World Forum for Harmonization of Vehicle Regulations

Working Party on Passive Safety

UN Regulation No. 127 (Pedestrian safety)

Proposal for Supplement 1 to the 04 Series of Amendments to UN Regulation No. 127 (Pedestrian safety)

Figure 12
Windscreen test area

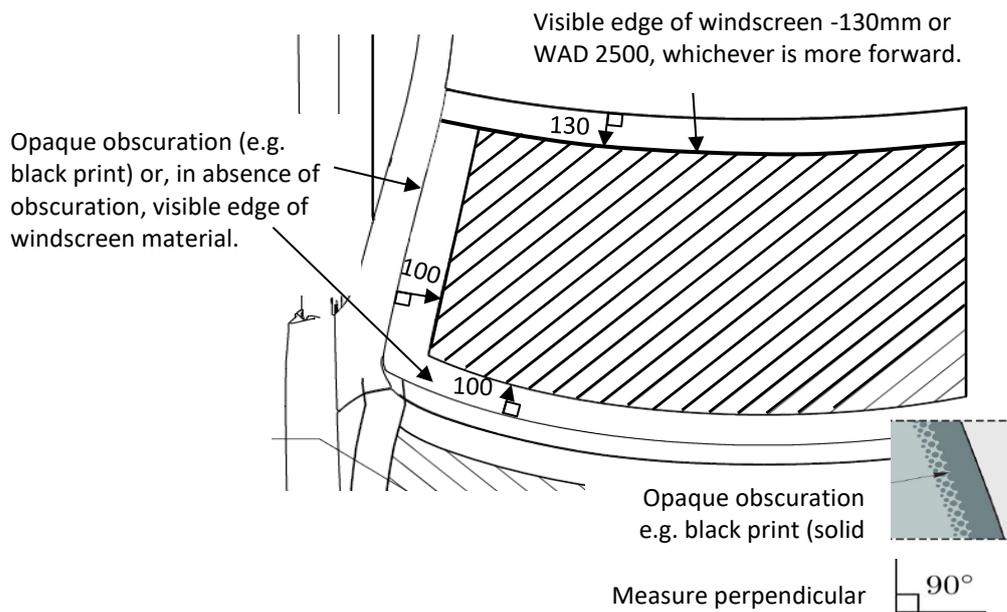
Paragraph 2.44., amend to read and insert Figures 12 and 13:

- "2.44. "Windscreen test area" is an area on the outer surface of the windscreen. It is bound (**see figure 12**):
- (a) In the front, by a line 100 mm rearward to the opaque obscuration of the windscreen. In case of absence of the opaque obscuration, the line is measured from the front visible edge of the windscreen material.
 - (b) In the rear, by a WAD 2,500 or a line 130 mm forward to the rear visible edge of the windscreen material, whichever is more forward at a given lateral position.
 - (c) At each side, by a line 100 mm inside the opaque obscuration of the windscreen. In case of absence of the opaque obscuration, the line is measured from the side visible edge of the windscreen material.

For (a) and (c): the distances of 100 mm are to be measured with a flexible tape held tautly along the outer surface of the vehicle at an angle of 90° to the tangent line to the opaque obscuration limit or in case of absence of the opaque obscuration, from the visible edge respectively.

For (b): the distances of 130 mm is to be measured with a flexible tape held tautly along the outer surface of the vehicle at an angle of 90° to the tangent line to the rear visible edge of the windscreen.

Figure 13
Upper corner definition with "shortest distance"

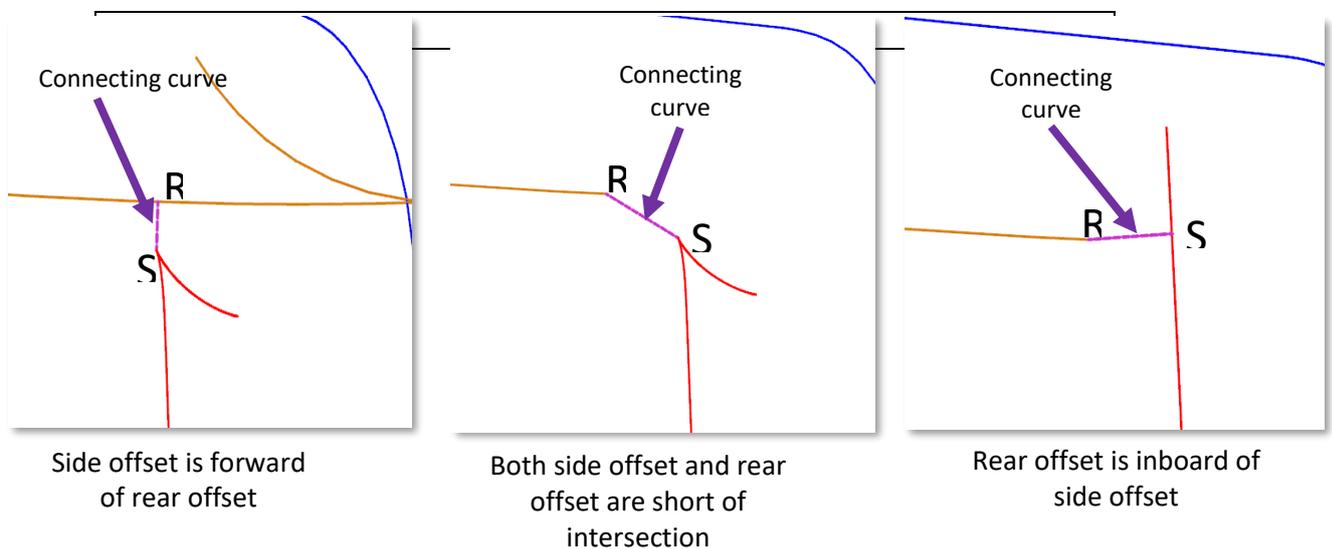
Depending on the geometry, in case there is no intersection between (b) and (c), resulting in an open test area, then the marking shall be modified using the shortest distance to close the open test area (see figure 13).

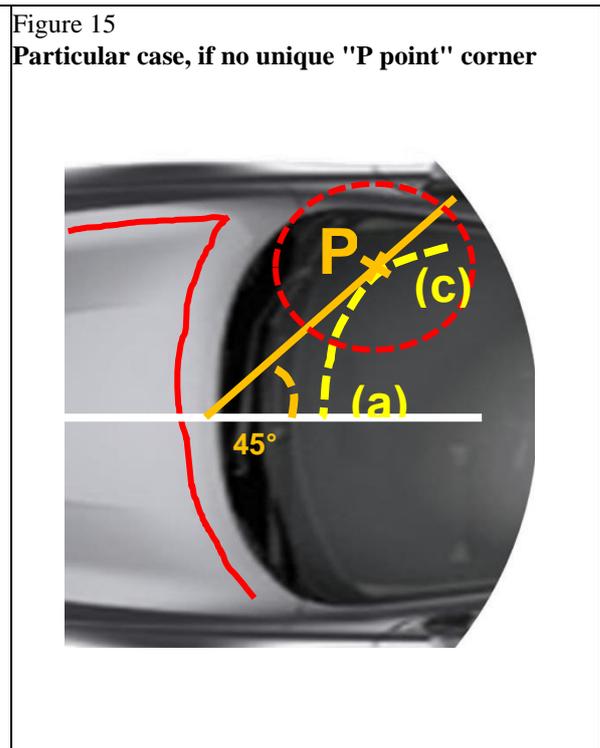
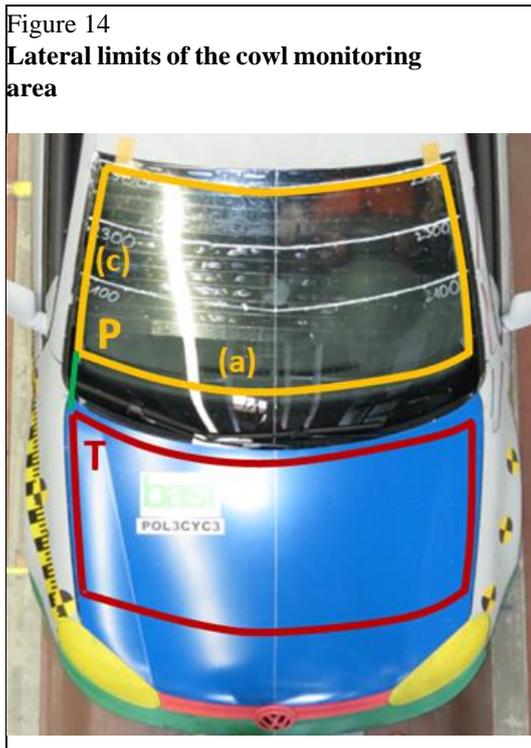
Paragraph 2.45., insert Figures 14 and 15 and amend to read:

At each side, the cowl monitoring area is bound by the TP line (see figure 14), where:

- (a) the "T point" is the rear corner of the bonnet top test area; and
- (b) the "P corner point" is the lower corner of the windscreen test area; using a flexible tape held tautly from point T to P.

If there is no unique "P point" where the lines defined in 2.44 (a) and (c) intersect, then the "P point" is defined by the first contact of a vertical plane intersecting the vertical longitudinal vehicle center-plane at an angle of 45° with the (a)-(c) transition of the windscreen test area boundary, as shown in Figure 15.

Figure 16

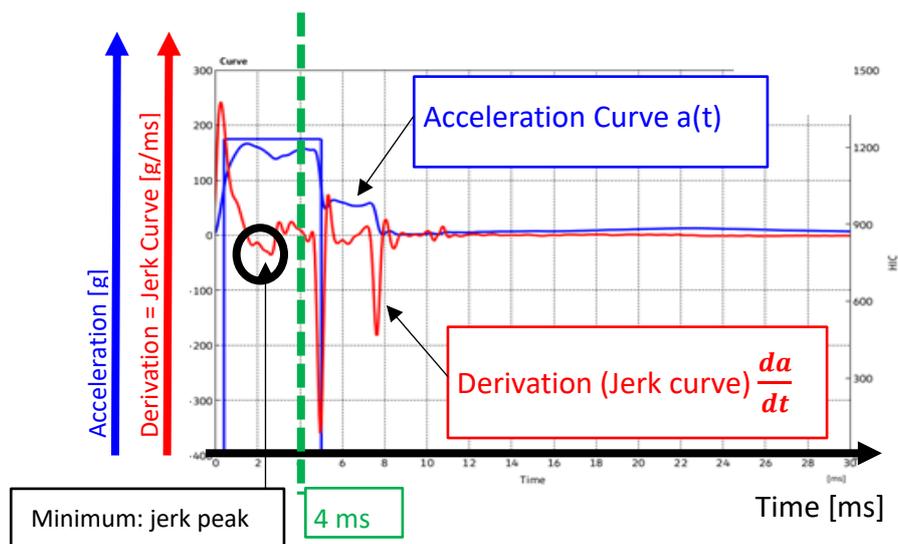
Paragraph 2.48., insert Figure 16 and amend to read:

- (a) The absolute value of the minimum value of the derivation of the headform acceleration versus time is ~~below~~ **less than** 180 g/ms ~~for~~ **within** the first 4 ms after the initial contact of the headform to the windscreen, **as shown in Figure 16**; or

$$\left| \min \left(\frac{da}{dt} \right) \right| < 180 \text{g/ms, for } 0 < t < 4 \text{ms}$$
